Subject: A Solution Tank Kit, p/n 56109561, is now available for the Adphibian, BA and Convertamatic. The kit includes a new-style solution tank, new-style squeegee lift lever and lever mounting hardware.

Models Affected: Adphibian, BA 625, BA 725, BA 725C, BA 825, Convertamatic (all models); all machines prior to serial number 2059967

ECO# : A-03923, A-04273

Figure 1 – New-style Solution Tank and Squeegee Lift Lever

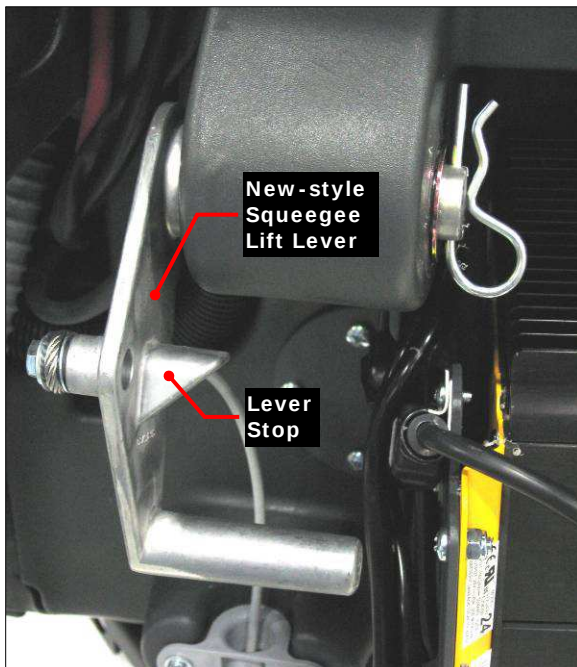
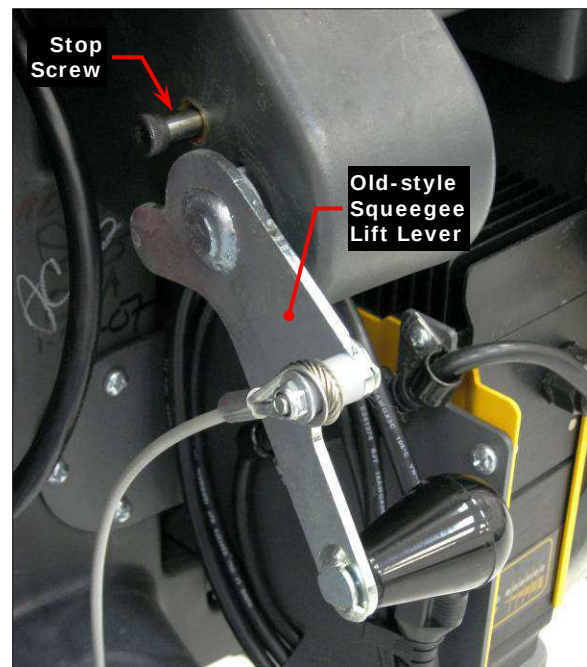
Informational Bulletin: The squeegee lift lever on the 24-volt walk-behind scrubbers has been redesigned to include a lever stop as part of the lift lever casting, and the new-style solution tanks currently in production no longer have a stop screw or mating threaded tank insert (Figure 1). As a result of this design change, the old-style squeegee lift levers cannot be used with the new-style solution tanks.

If you replace a solution tank (with stop screw) and your machine has the old-style squeegee lift lever (Figure 2), you must install a new-style squeegee lift lever when you install a new solution tank. In this case you will need to purchase the Solution Tank Kit (p/n 56109561) which includes a new solution tank, and a new-style squeegee lift lever and mounting hardware.

Figure 3 – New-style Squeegee Lift Lever and Mounting Hardware

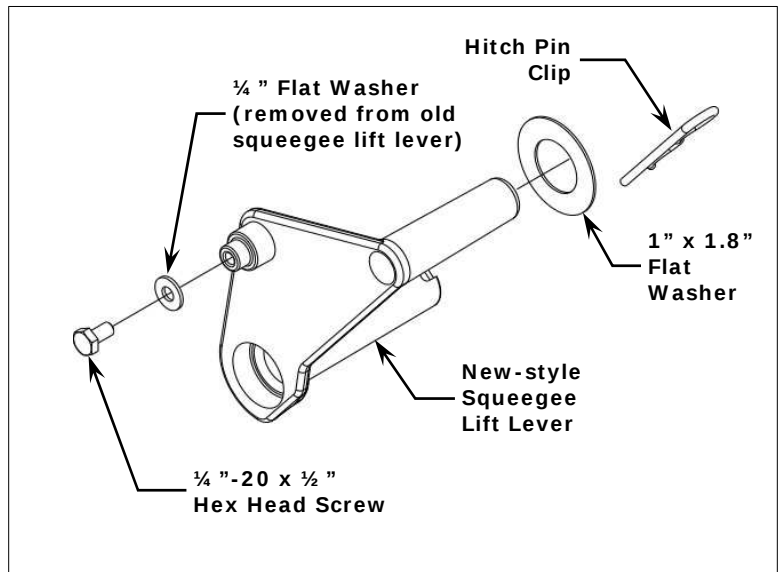
Note: See Figure 3. You will need to use the 1/4" flat washer removed from the old squeegee lift lever assembly when installing the squeegee lift cable onto the new-style squeegee lift lever.
